## **Appendix G: RFLMA Contact Records**

## **Contact Record 2008-01**

## ROCKY FLATS SITE REGULATORY CONTACT RECORD

**Purpose:** Completion of Additional Ecological Sampling in accordance with RFLMA Attachment 2, Table 5

Figure 1. Dam Breach Project: A-Ponds Project Locations

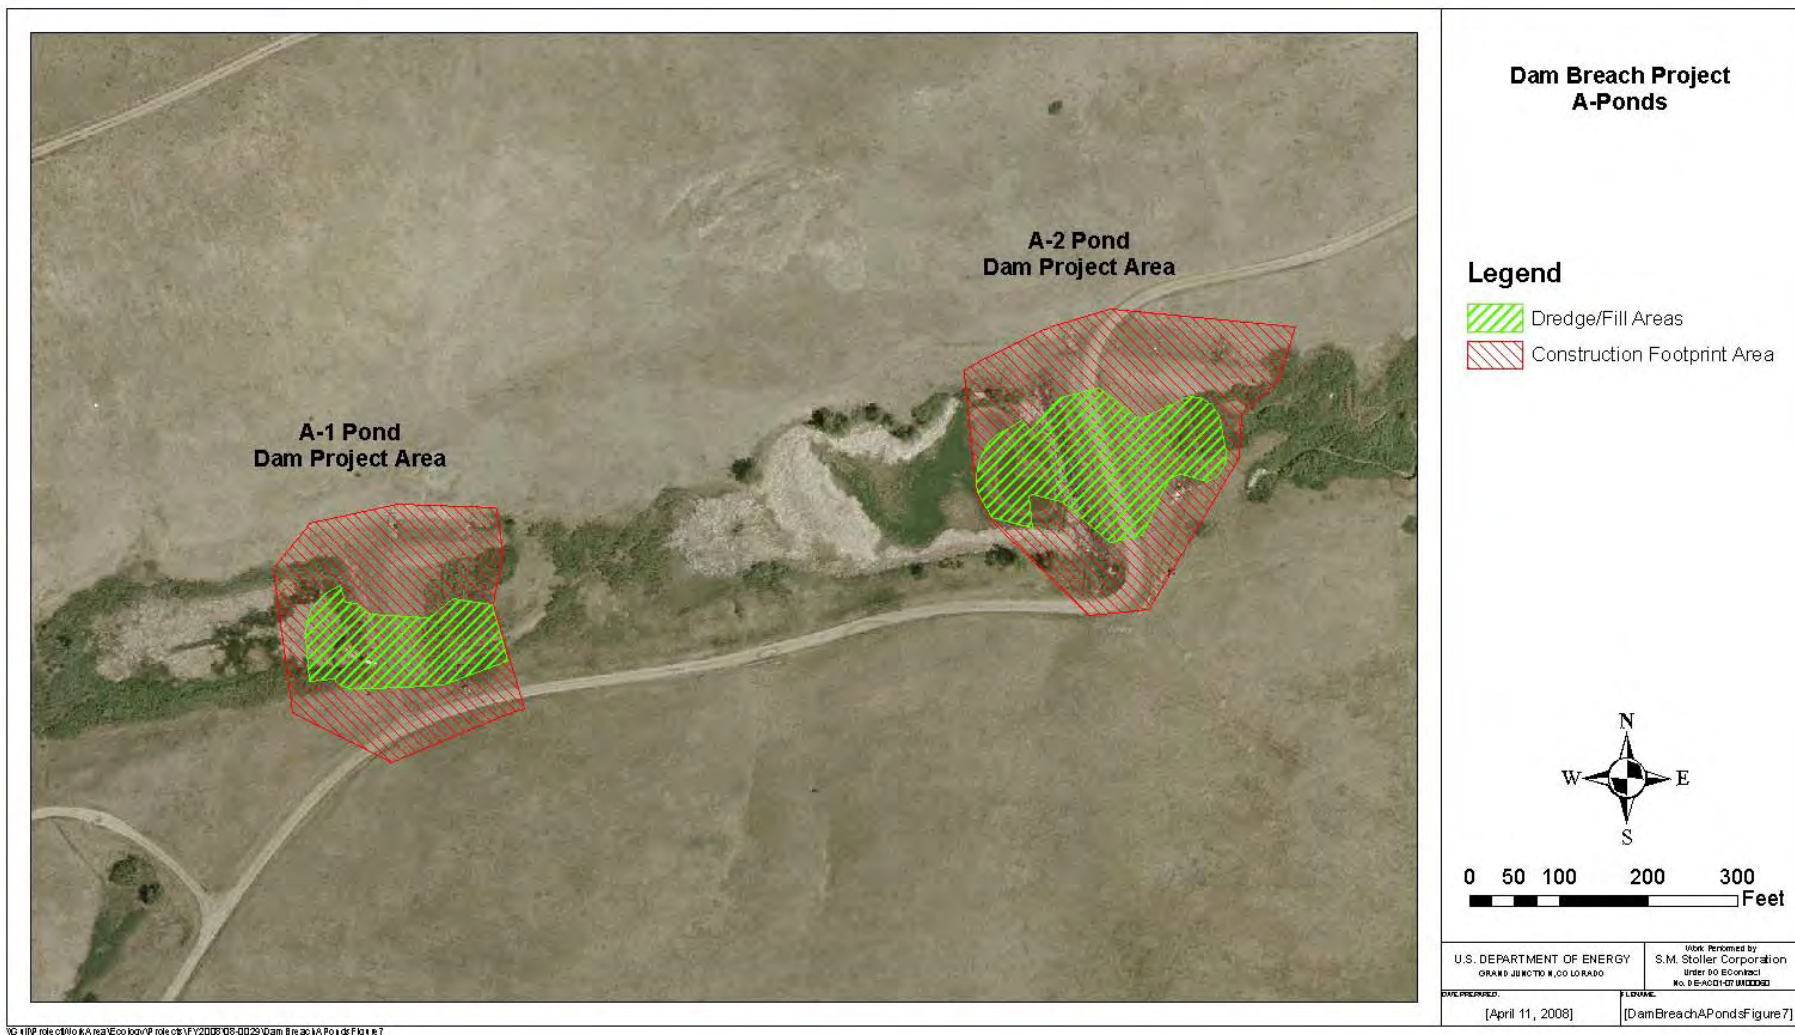
On March 6, 2008 and May 6, 2008, DOE, CDPHE and Stoller staff consulted regarding the proposed dam breaching. The attached Figures 1 and 2 show the footprints of the work area. Figure 3 shows the typical notch configuration to breach the dams. An associated stop log structure in each notch is designed to allow leakage during moderate flows and overtopping during high flows, thereby attenuating flow rates but not retaining significant quantities of water. Figure 3 also shows the typical stop log structure location in each notch. Figure 4 shows Dam C-1, after breaching in a similar manner was completed in 2005.

Figure 1. Approximate Location of TMST Transfer Line

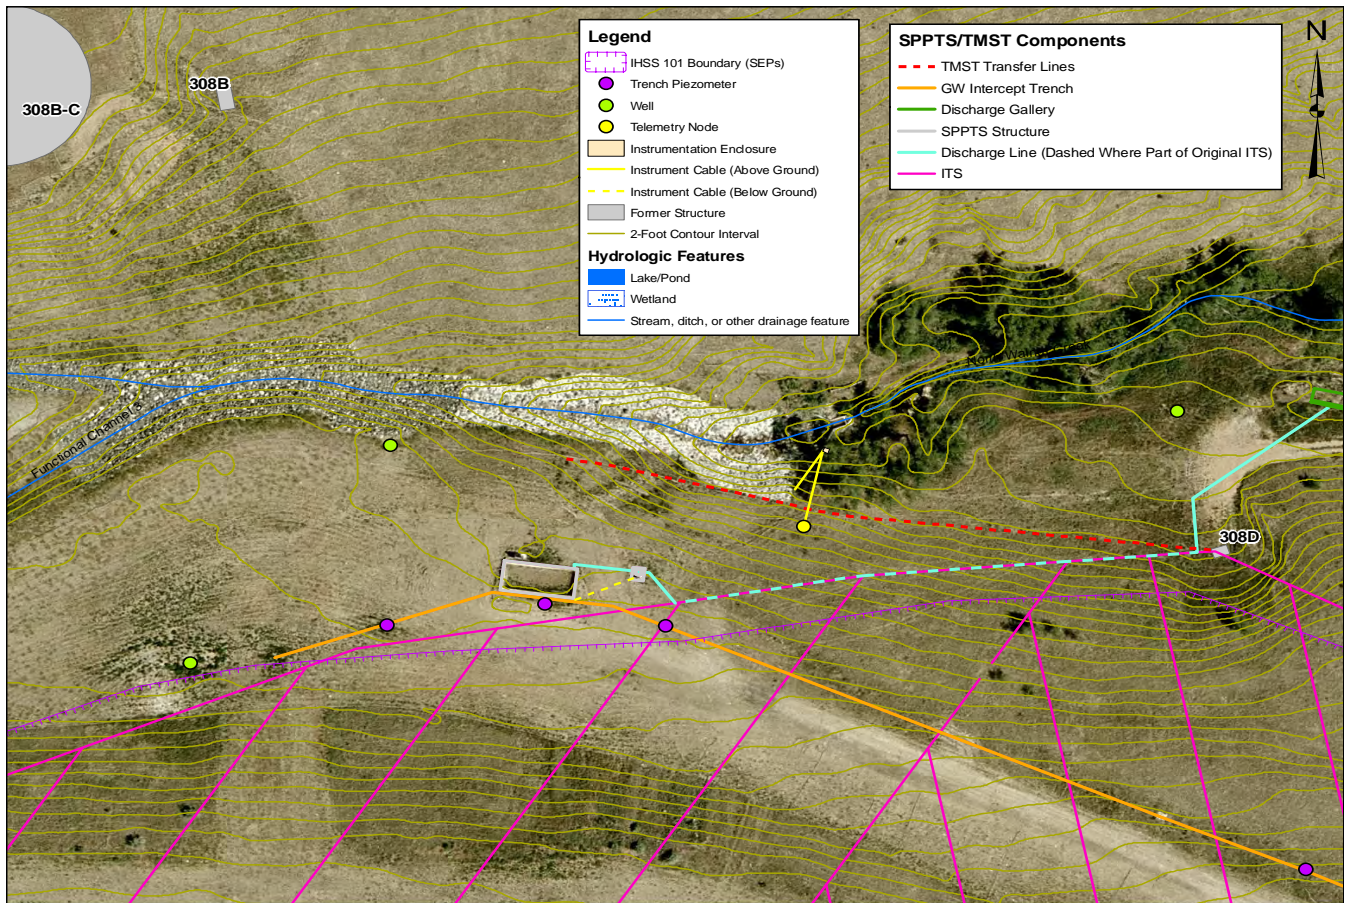
Two parallel lines are present in the subsurface near the ITPH. These lines were located during the exploratory excavations in spring 2007 (see *Contact Record 2007-02*) and appear to consist of HDPE pipe (non-perforated). Their purpose prior to site closure was to transfer water from the ITPH to the Temporary Modular Storage Tanks (TMSTs) and subsequently transfer the water from the tanks back through the ITPH into the Protected Area and finally to the evaporators within B-374 for treatment. Portions of these lines nearest the TMSTs and FC-3 have been removed, but the portion nearest the ITPH, extending to near the SPPTS, remains.

Engineering drawings that were generated before closure depict these lines as double-walled and show them running from the ITPH to the vicinity of the SPPTS before turning more northerly toward the TMSTs. They may be buried closer to the base of the hill (i.e., nearer surface water monitoring station SW093 than the SPPTS itself). Figure 1 shows the approximate location of the TMST transfer lines in relation to other features in the area. Regardless of whether the nearest portion is closer to the SPPTS or SW093, if these lines are in serviceable condition, they should be considered for use in the upcoming SPPTS modifications. Using them to transfer water from the new collection sump to the SPPTS could significantly reduce how much habitat is disrupted: the most sensitive portion of the habitat along the valley bottom, from the general vicinity of SW093 to the new sump, would not be directly impacted by the construction activities.

These lines will be investigated by using a backhoe or similar equipment and utility-locating equipment as follows:

Figure 1. Location of the Test Pits and Inclinator Boreholes and Observed Conditions at the OLF

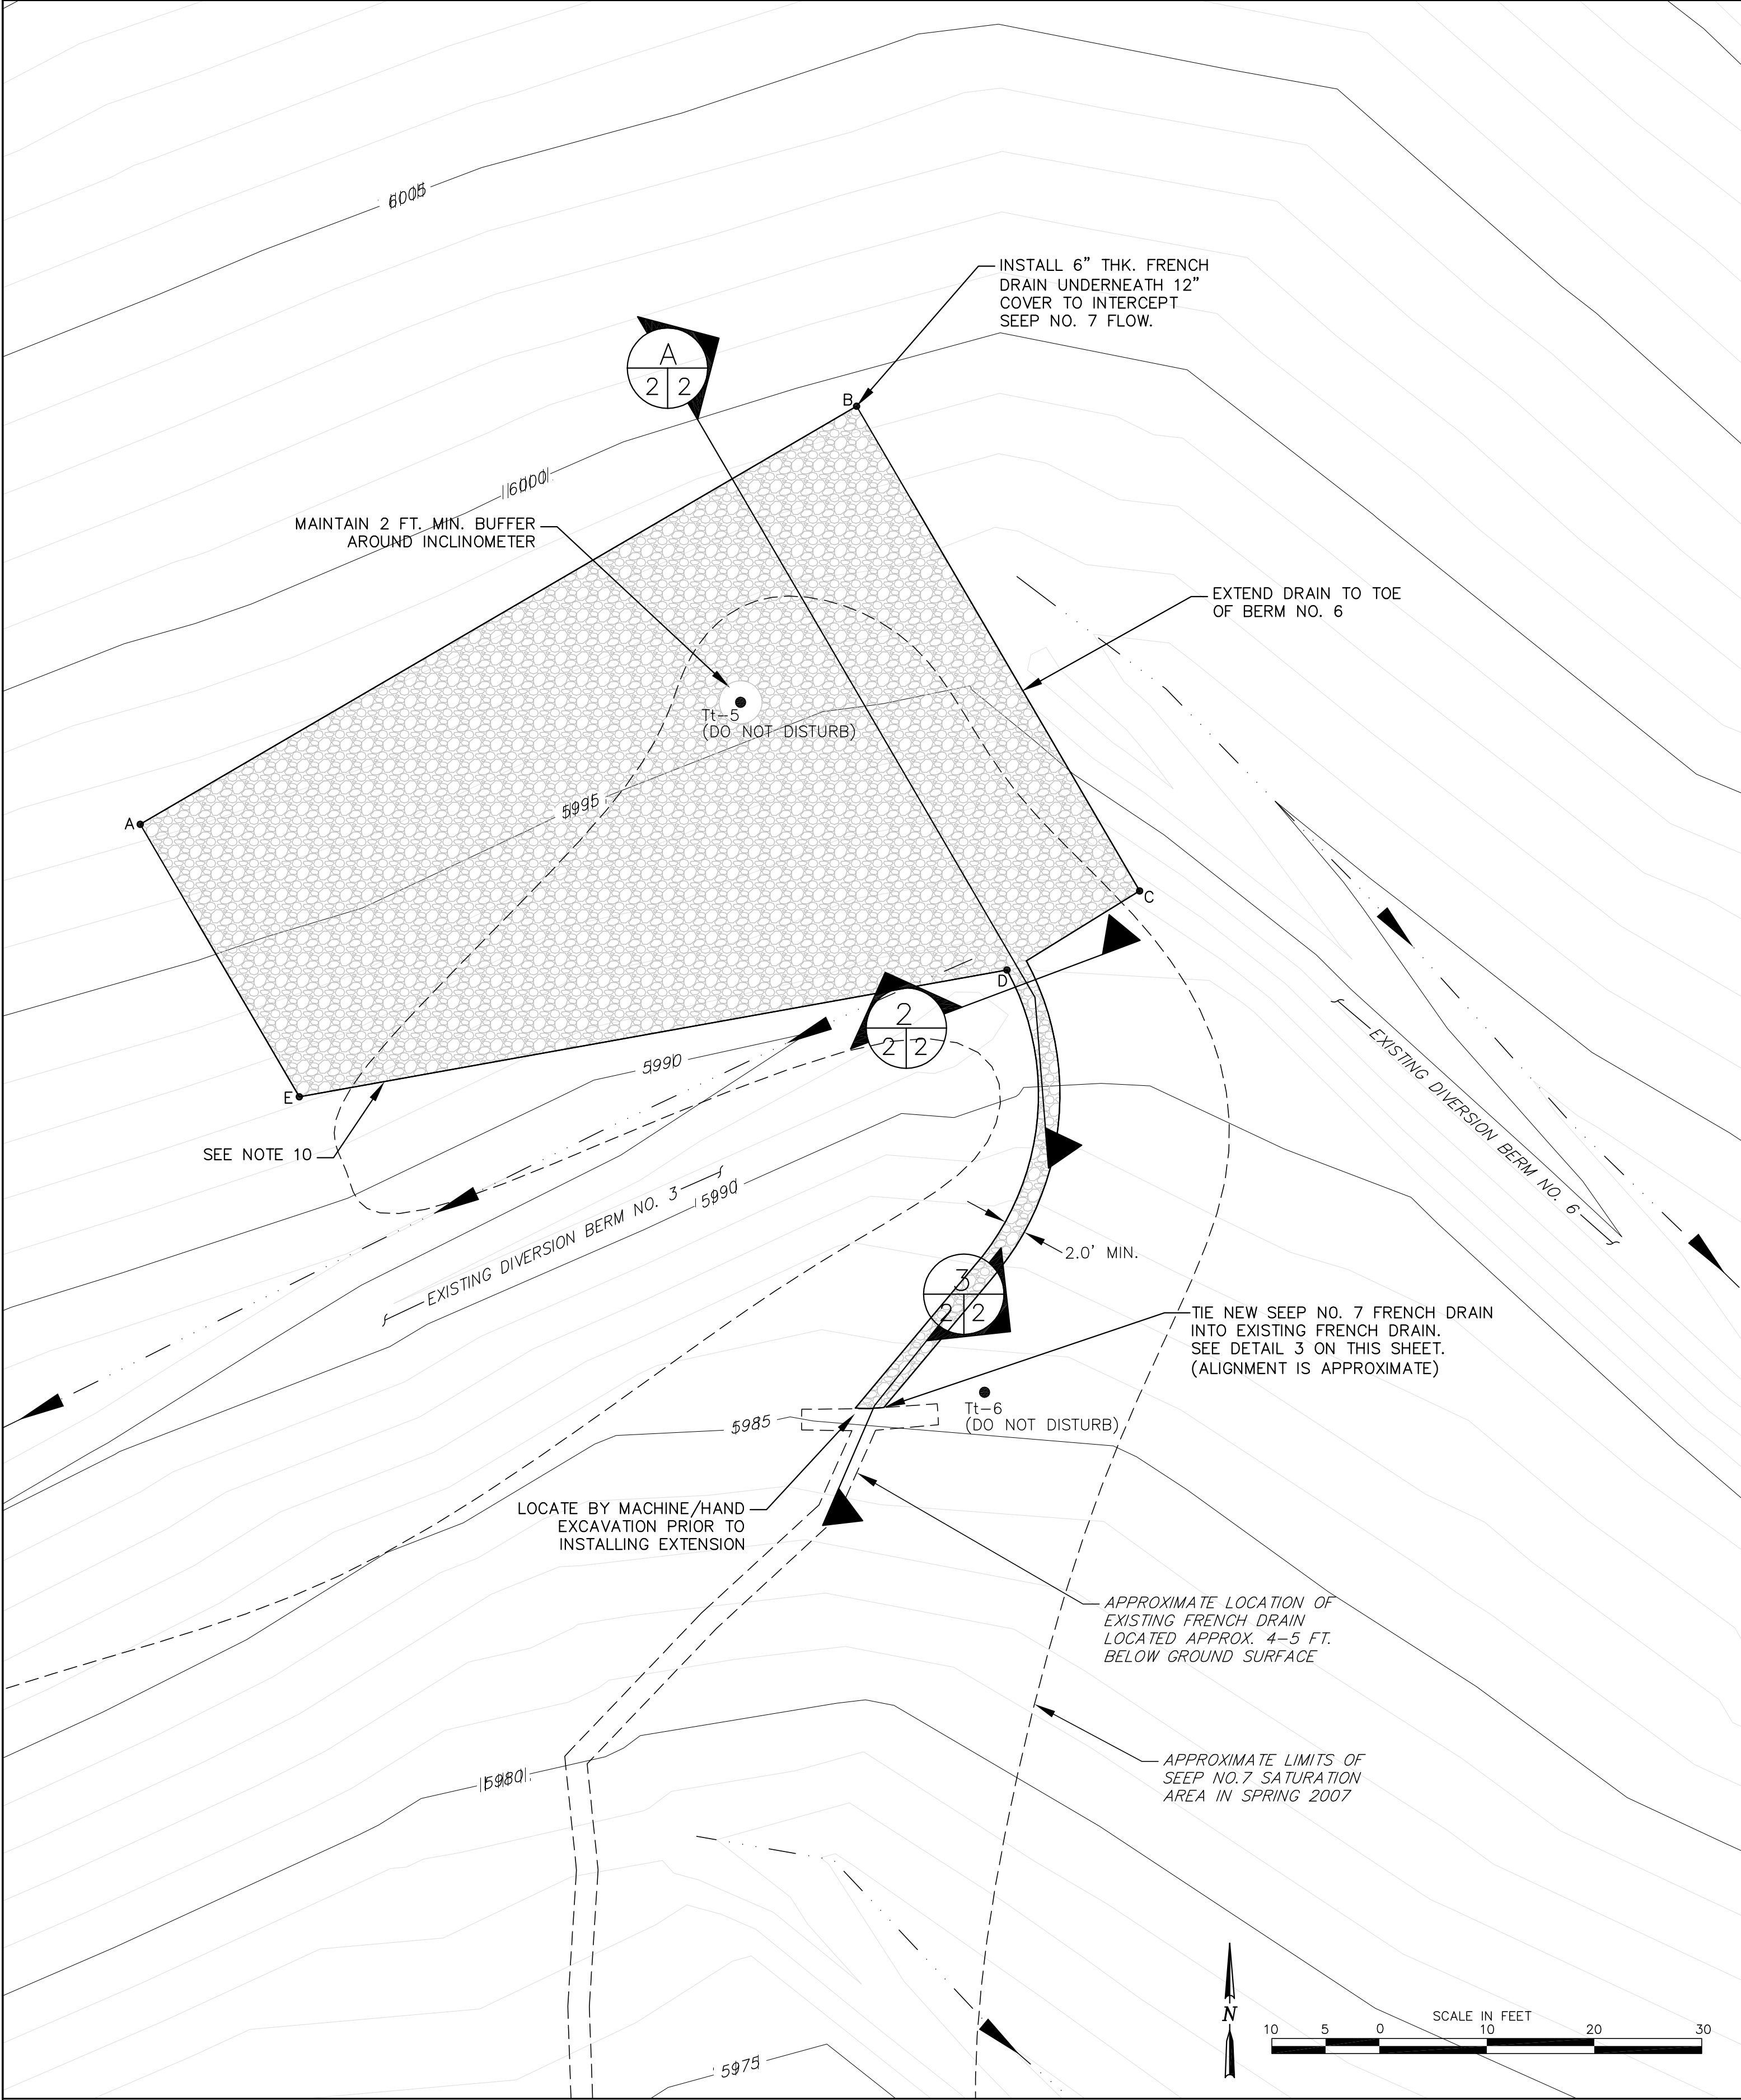
5. West perimeter channel side slope stability – An area generally between the western ends of Berms 1 and 3 (see Figure 1) will be regraded by cutting and filling to lessen the OLF side slope and improve stability. The perimeter channels' depth and size are much greater than the design drain capacity requires. The regrading plan will be based on cost-effective use of soils available in the areas adjacent to the slope areas being adjusted. Regrading will also be considered at other locations in the east and west perimeter channels to reduce side slopes and improve cover and channel stability. The permanent erosion control mat will be replaced where necessary.

The OLF M&M Plan will be modified to document the regraded channels, including updating the drawings to show the new contours, as necessary.
